SUNSET ROAD CLIFF ISLAND
109C-A-10-11-20-23-29

APPLICATION FOR PERMIT

Portland, Maine, May 5, 1937

Location Sunset Ave., Cliff Island Ward Isl. 1 Within Fire Limits? No Dist. No. _____

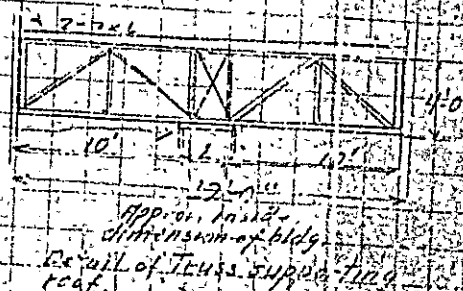
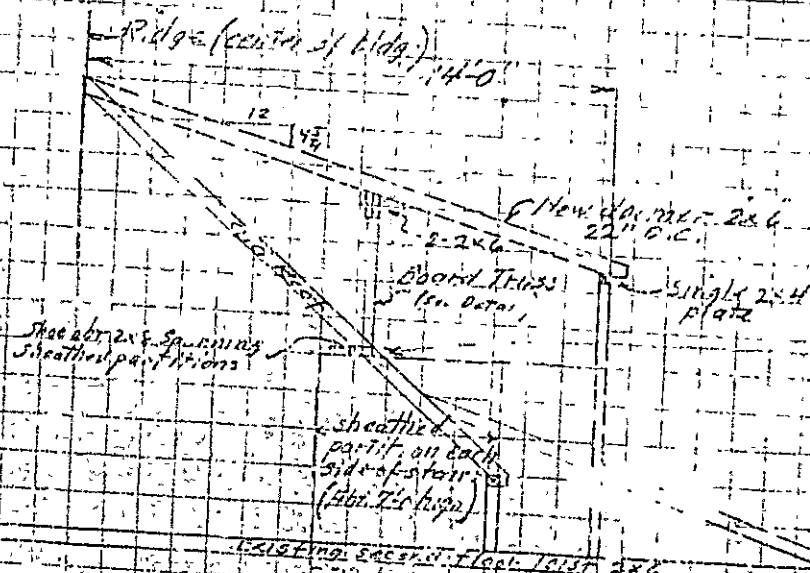
The inspector also reports that the framing of the corner window does not satisfy Code requirements as regards strength required to undoubtedly support the theoretical roof loads that are likely to come upon it and deliver these loads to the ground. This department is unable to direct in detail the strengthening of these details of framing, neither are we able to approve them.

Note: Truss is roughly constructed and it is questionable if joints are properly made to take care of loads they might receive. This is built mostly of 1x6 boarding.

I propose to hold this violation against you, personally, and indefinitely. It seems evident that you have not extended yourself in any way to cooperate with this office in its sincere efforts to get substantial and serviceable buildings within the city limits, and I feel that it is only in line with my duty to advise you that further violations on your part or failure to make good these chimneys will result in action against you without further notice, as directed by law.

4x6 beam

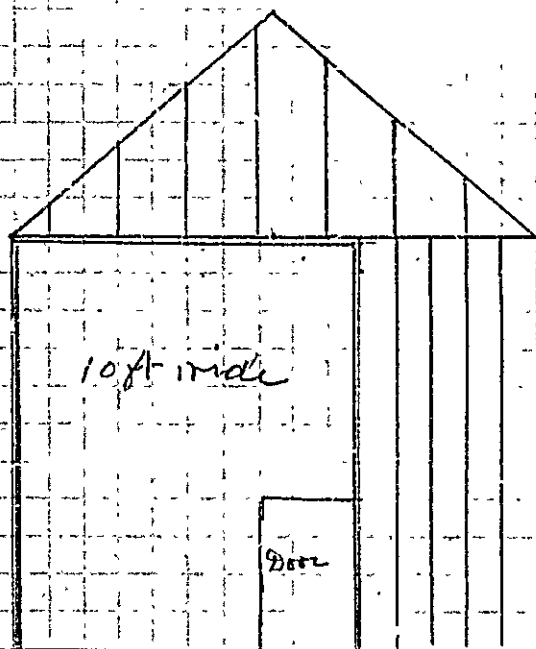
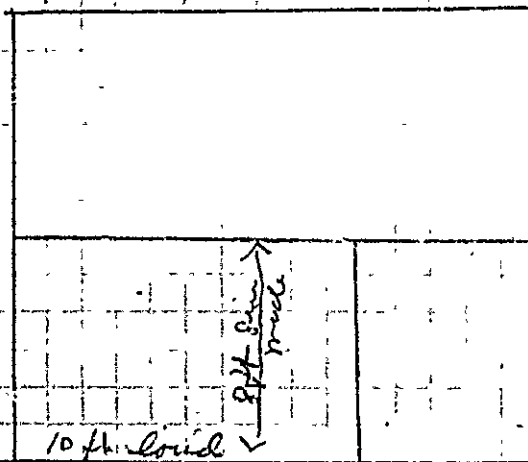
The distance of the floor
timbers from ~~one~~ the outer
plate to the next center plate
is 9 ft 8 in wide so there would
be a little over four (4) ft
that the new beam would
be supporting and I think
the 4x6 would be heavy enough.

In order to determine whether or not the 4x6 on whatever span is correct, is heavy enough, we shall have to know whether or not the joists supporting the second floor rest upon this wall to be removed, and if they do rest upon this wall, what the span of the joist is between bearing. The owner stated that the rafters of the cottage also get a bearing over this partition to be removed, and if this is the case, we shall have to know the pitch of the roof and the total width of the cottage measured across between the bases of the rafters, so that we may take half of this distance to determine the load coming upon the timber which you propose to use.

As nearly as we can figure from the information which you have furnished, the load which Mr. Merrill proposes on the 10' span is not quite heavy enough. We figure that the load deposited on this beam from the second floor of the cottage would be about 1900 lbs., from the roof of the extension about 675 lbs., and from the hip roof of the cottage 375 lbs.- a total of about 2950 lbs. A 12x8 on a 10' span figures good for only about 1900 lbs. A 12x8 or 2-2x8s set side by side with the eight inches vertical would be satisfactory.
